City of Santa Barbara California

PLANNING COMMISSION STAFF MEMO

AGENDA DATE: March 18, 2010

SUBJECT: 825 De la Vina Street (MST2007-00400)

Drawing: SITE/FIRST FLOOR PLAN

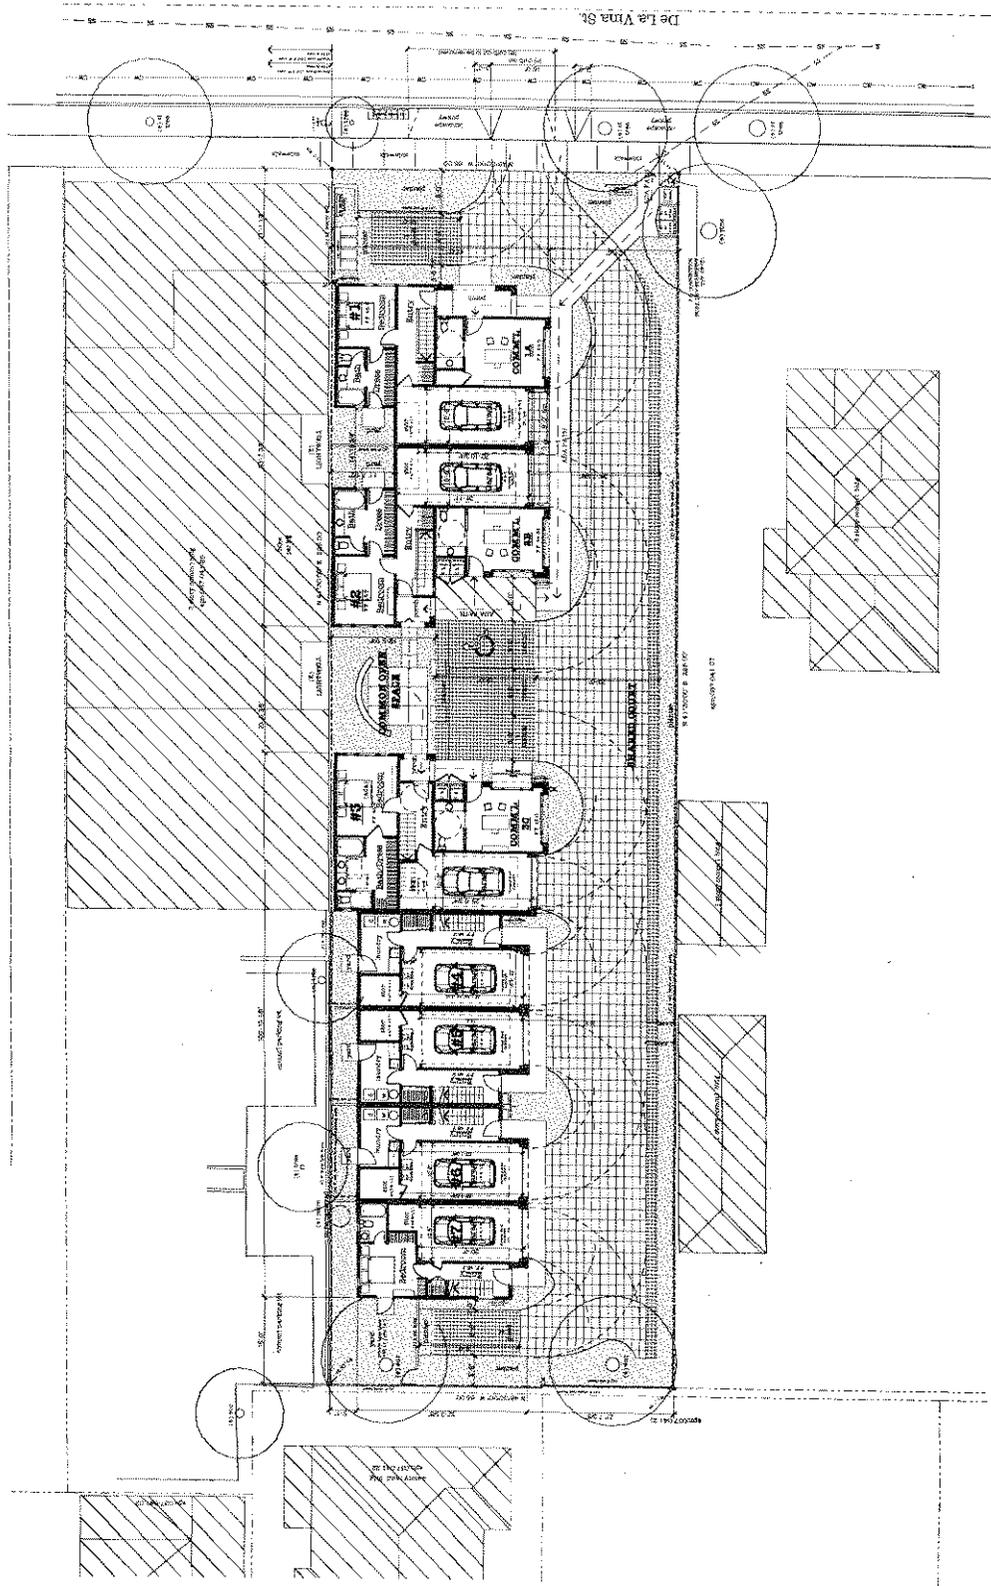
1. Eliminated the modification request by increasing the rear yard setback from 10' to 16' on the first and second floors.
2. Individual trash storage within units 4,6 & 7's private garages was eliminated and placed in a common trash enclosure.

3. Increased the setback from 28'-3" to 33'-11" on the third floor
4. Relocated one of the guest parking spaces from the front of the building to the rear of the site.
5. Increased the amount of landscaped area along the front property line
6. Increased landscaped along the southern property line
7. Reduced the size of each unit, resulting in a 7% reduction in the overall building size.
8. Added architectural refinements such eliminating the roof overhangs and the pitched roofs, reducing the size of the third floor trellises and east elevation, redesigned the trellises at the North and West elevations

The landscape area along the Southern property line at the edge of the auto court was doubled in width from 18" to 36". In addition a two foot wide planted paver edge was added along this side of the auto court resulting in a 5' wide band of planting material.

WEST ELEVATION

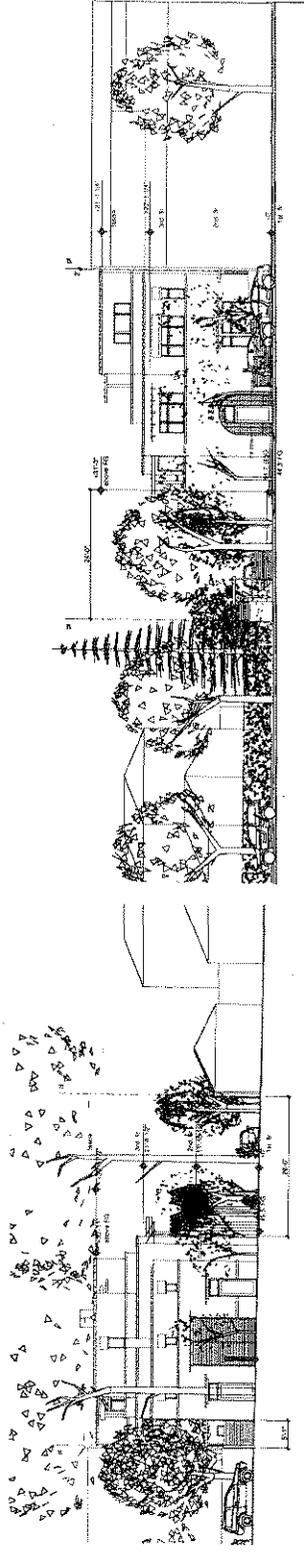
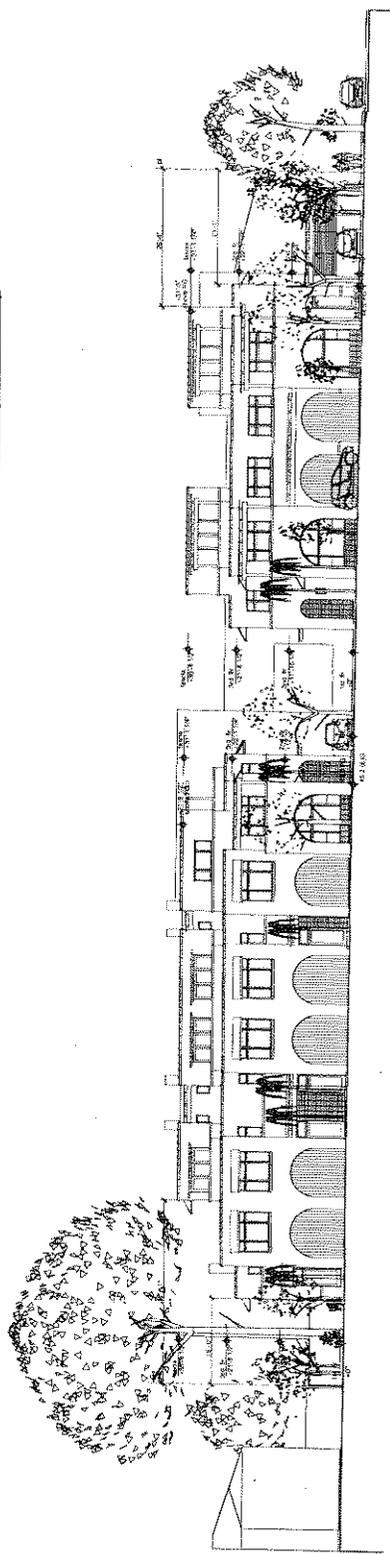
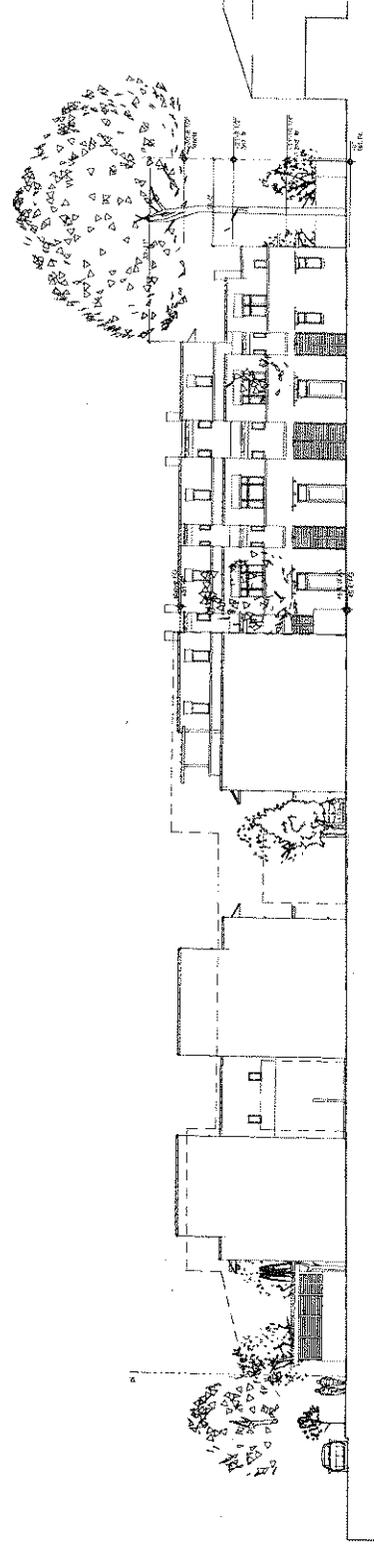
As directed by the ABR the roof overhangs and pitched roof sections have been eliminated and the trellises at the third floor and East elevation have been reduced in size. The North and West elevations were redesigned as suggested by ABR to better integrate into the overall design. As a result the projecting second floor bays were eliminated and additional breaks, windows and relief were added on the North facade. Per the ABR additional scale giving elements and details such as trellises, awnings, moldings and trim were added. Key elevation walls were thickened to add shadow and mass. A central mailbox location has been added at the pedestrian entry. The scale of the permeable paving pattern of the auto court was reduced to a smaller scale pattern as directed by the ABR.

With input from the neighbors the West elevation was revised to include additional architectural details such as lattices, trellises and awnings. Neighbor input on the landscape design resulted in revisions to the plant selections along the South and West property lines to include the use of more palm species in these areas.
